CATS-M Cantonment Roads & Parking Construction Project

PROJECT NO. 31090657

A D D E N D U M N O . 1

STANDARD DETAILS

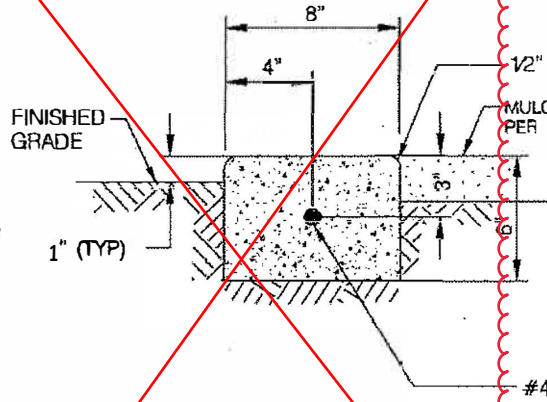
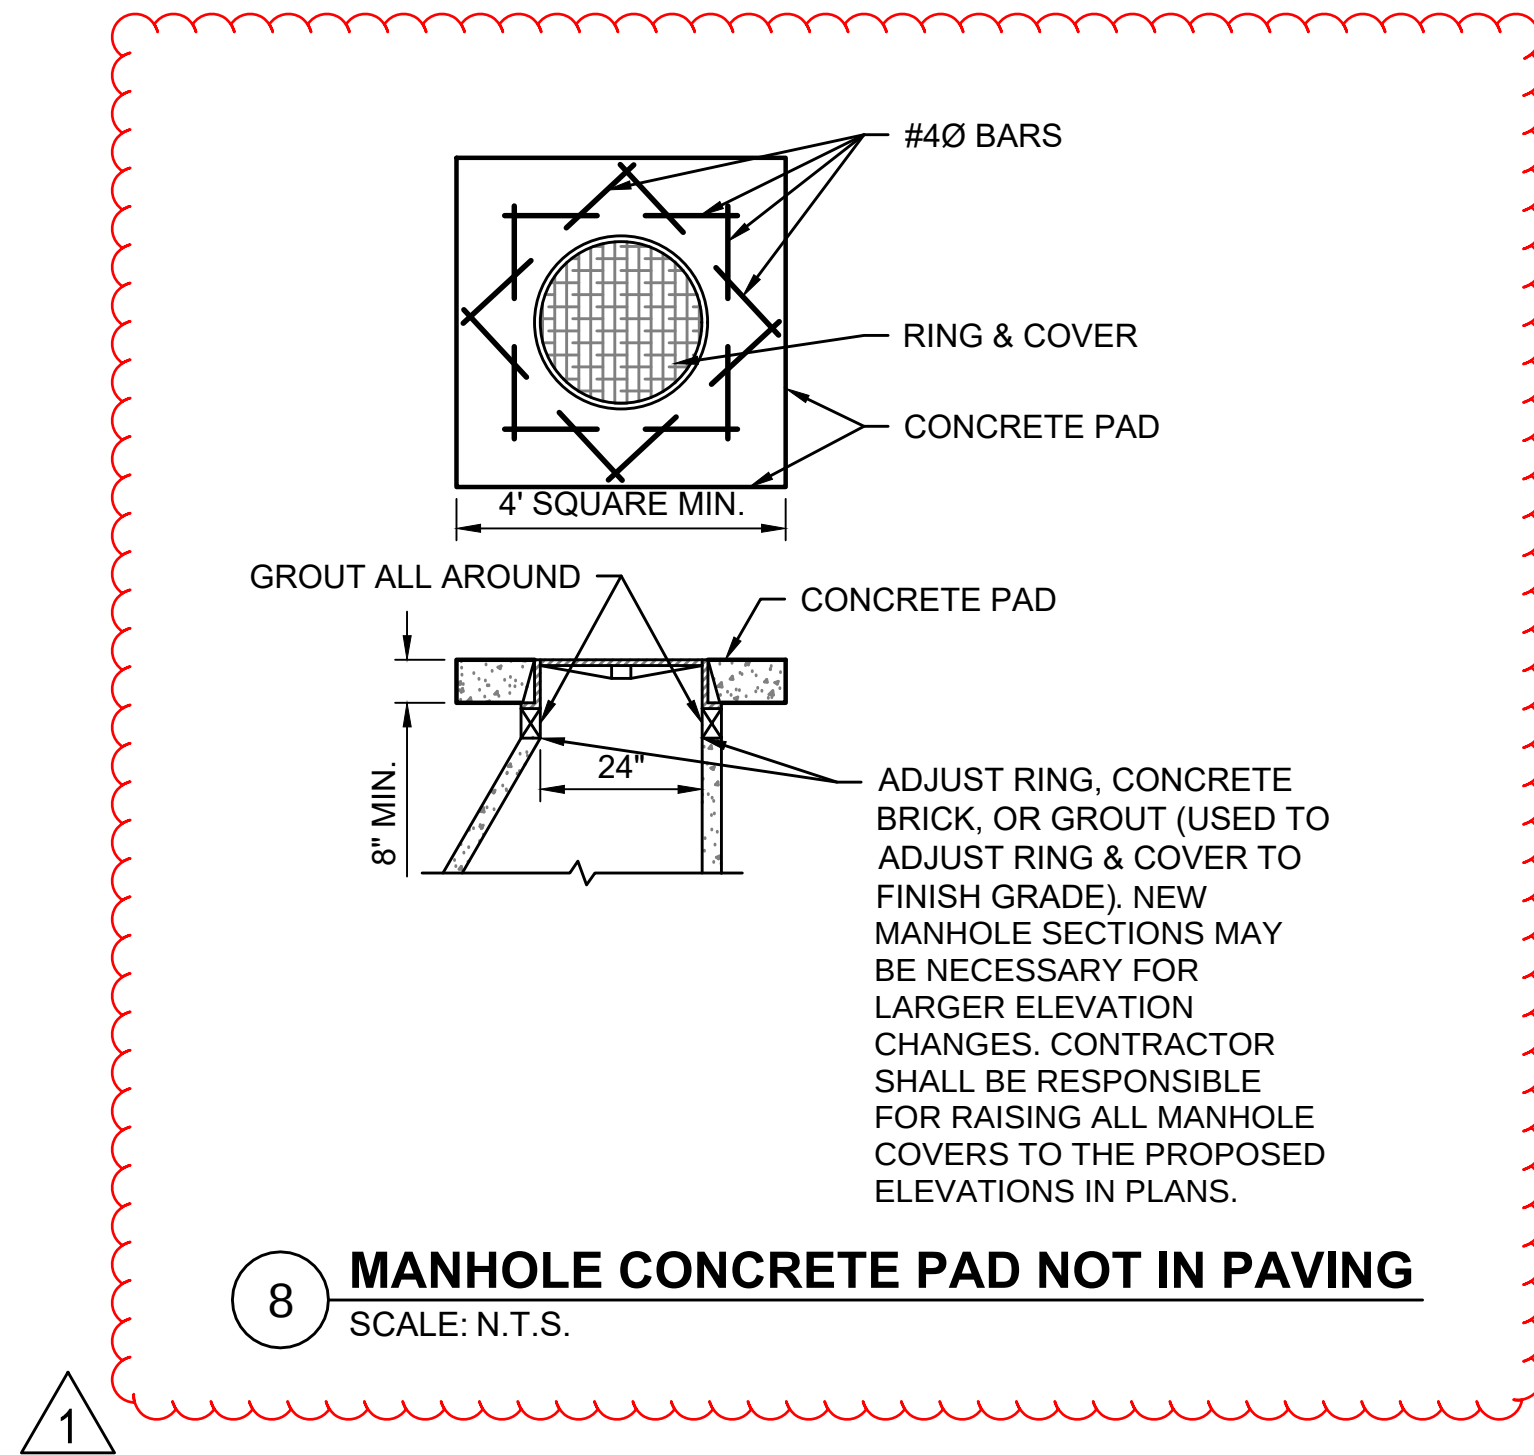
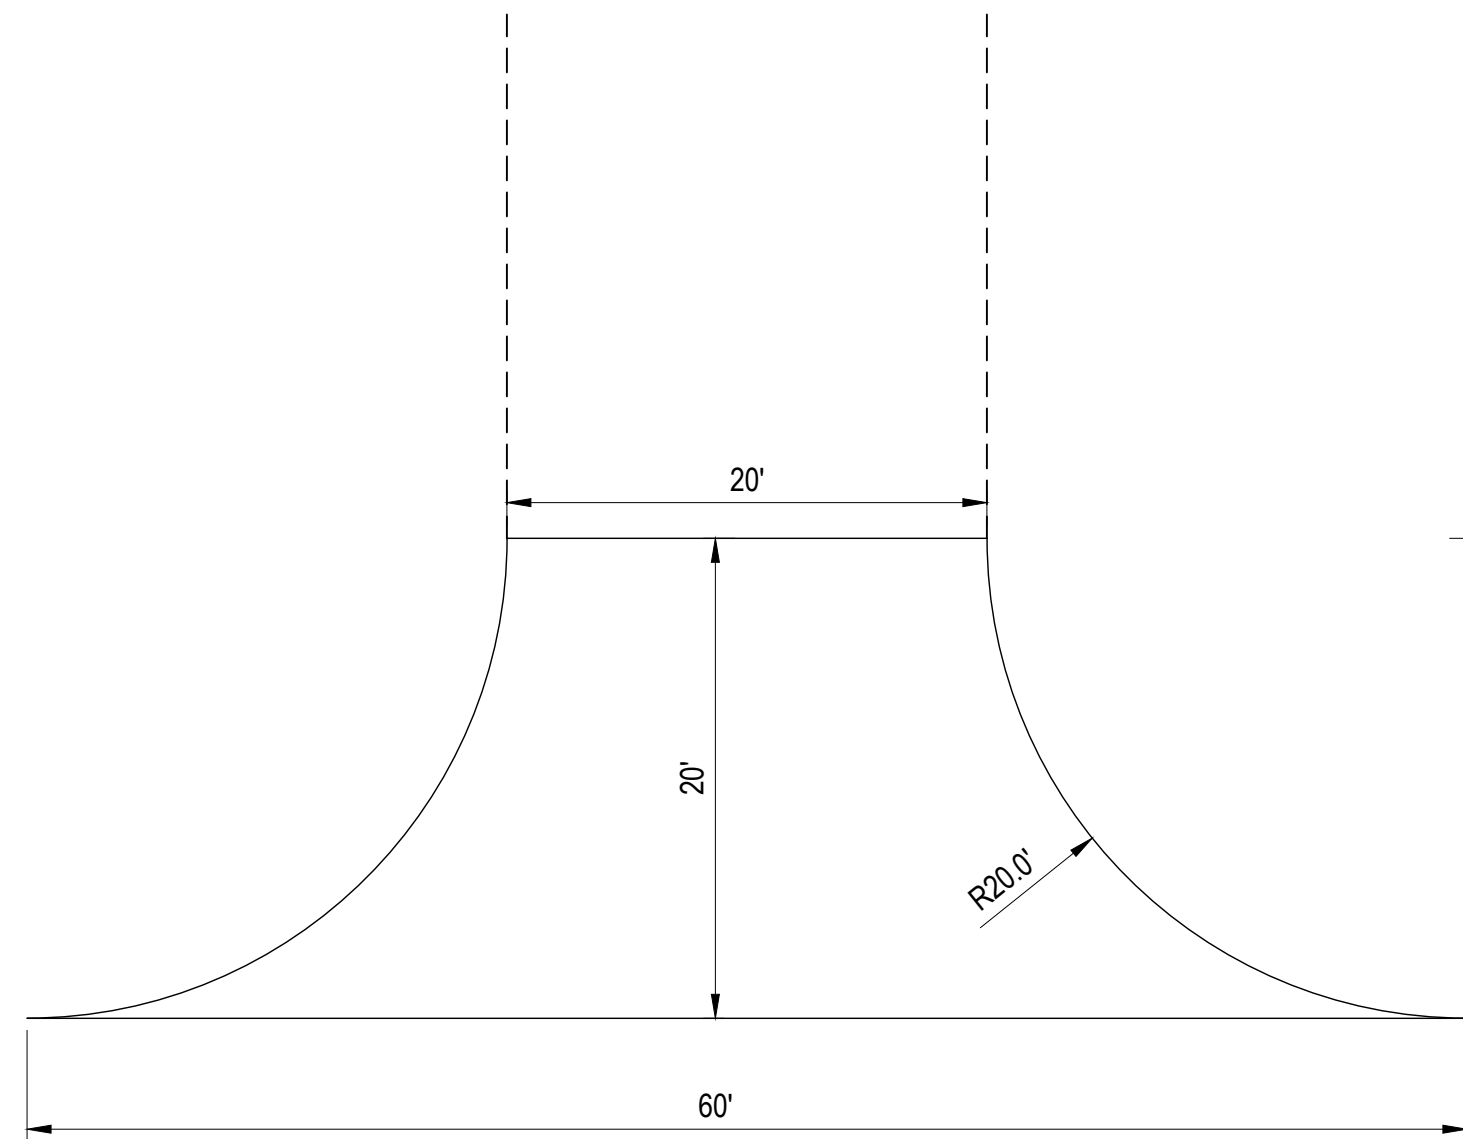
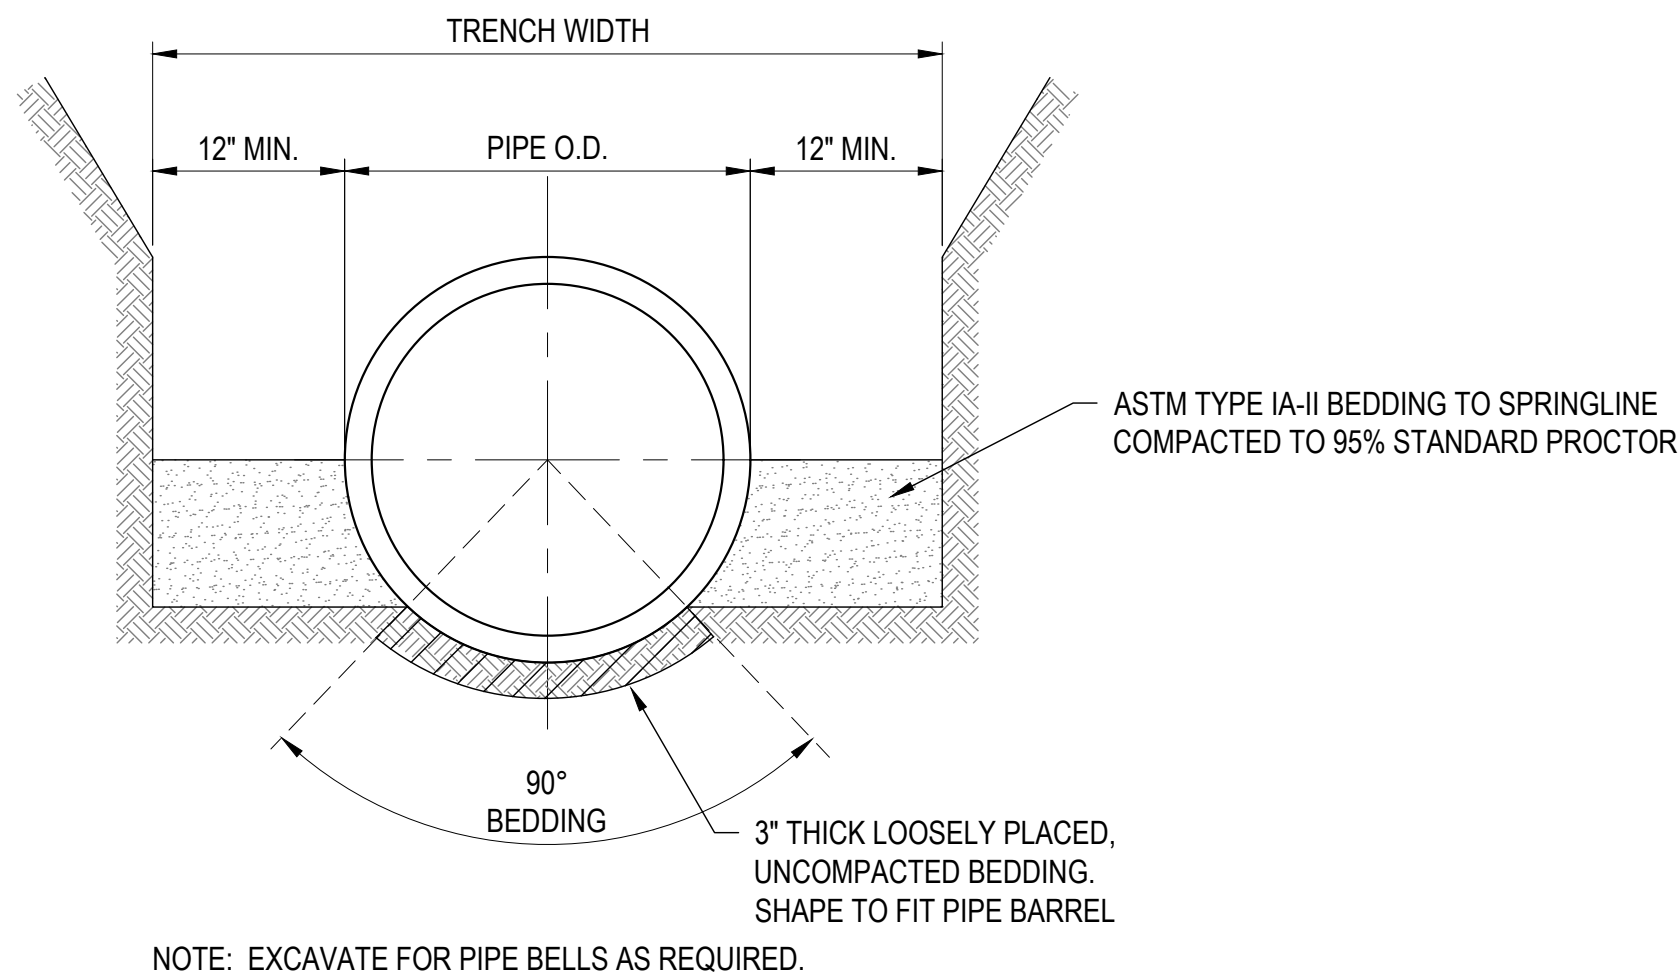
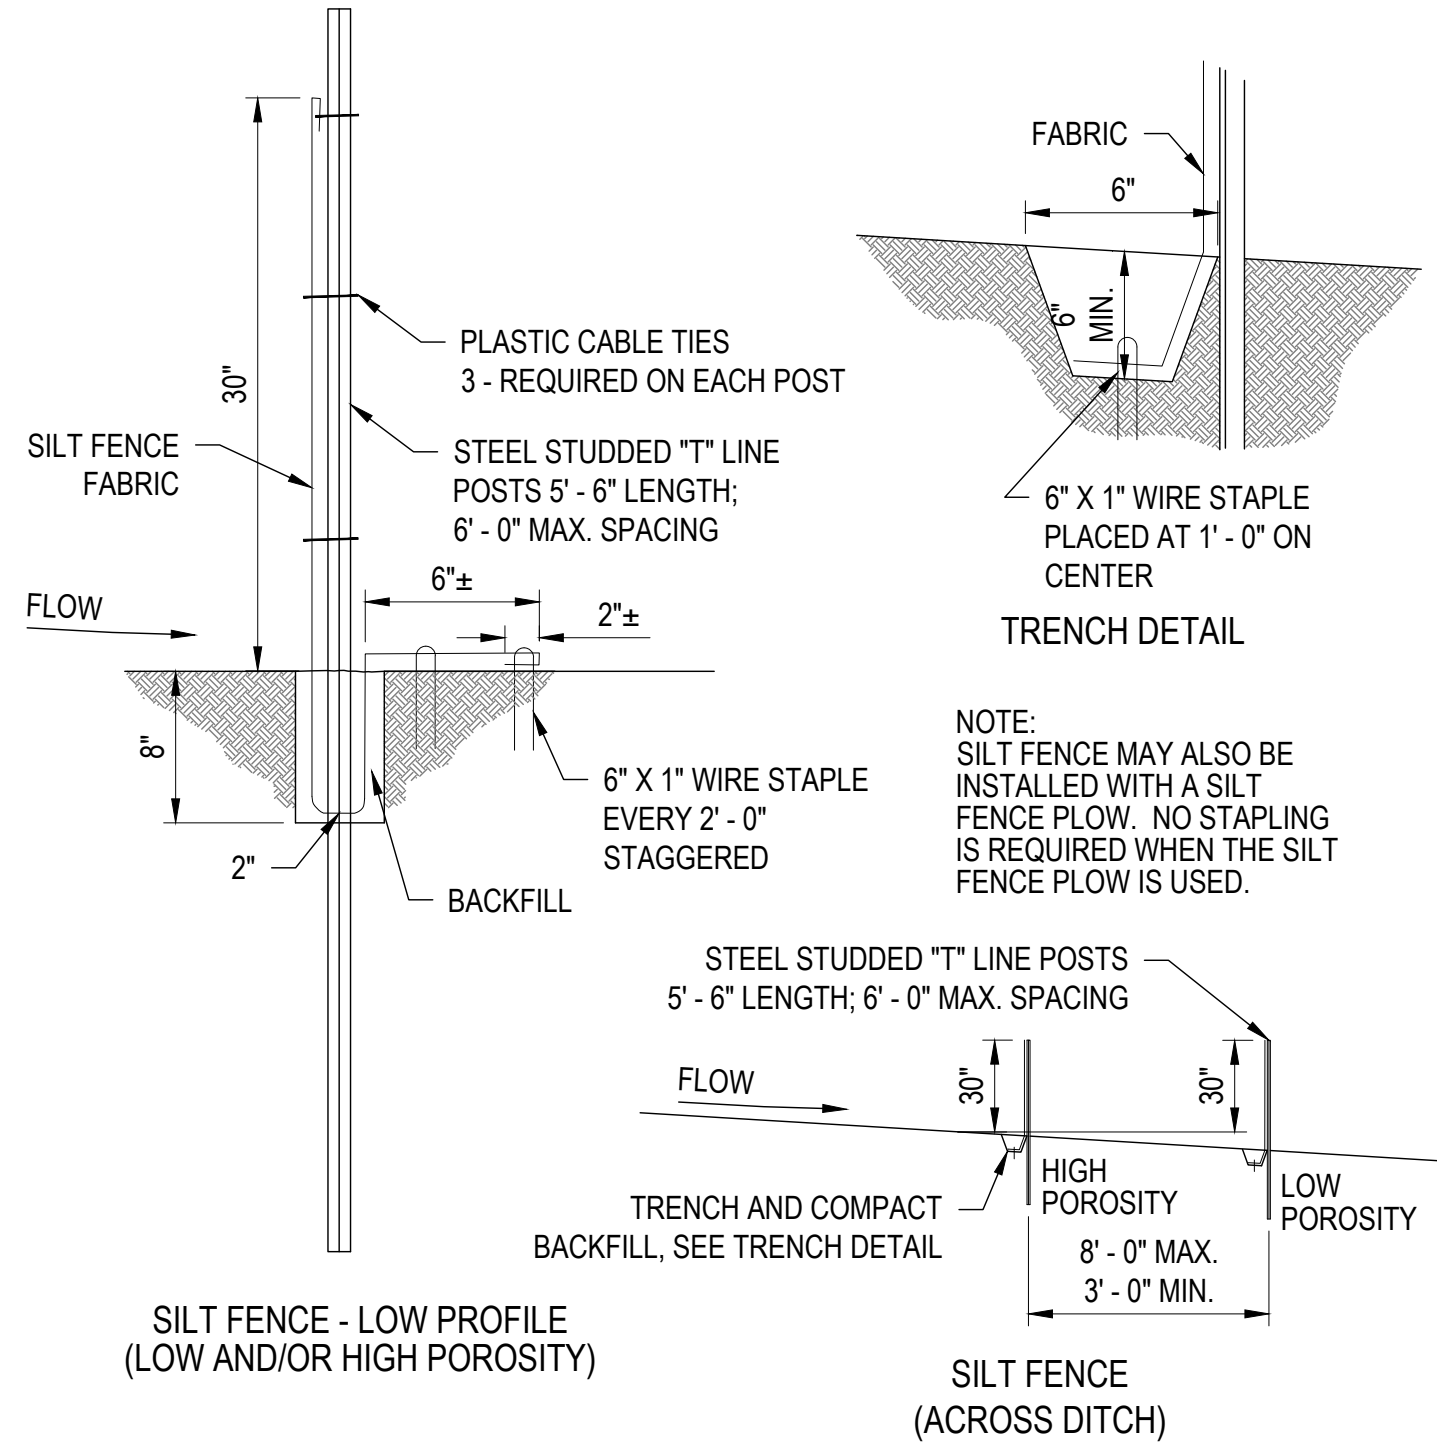
1. Sheets G001 (Cover) and D200 shall be deleted and replaced with the attached revised sheets to include manhole detail, bearing revision number 1.

- All manholes shall be raised to the proposed grade of the new roadway. Please reference plan sheets C300 and C301 for proposed elevations.
- See revised sheet D200 for manhole detail.
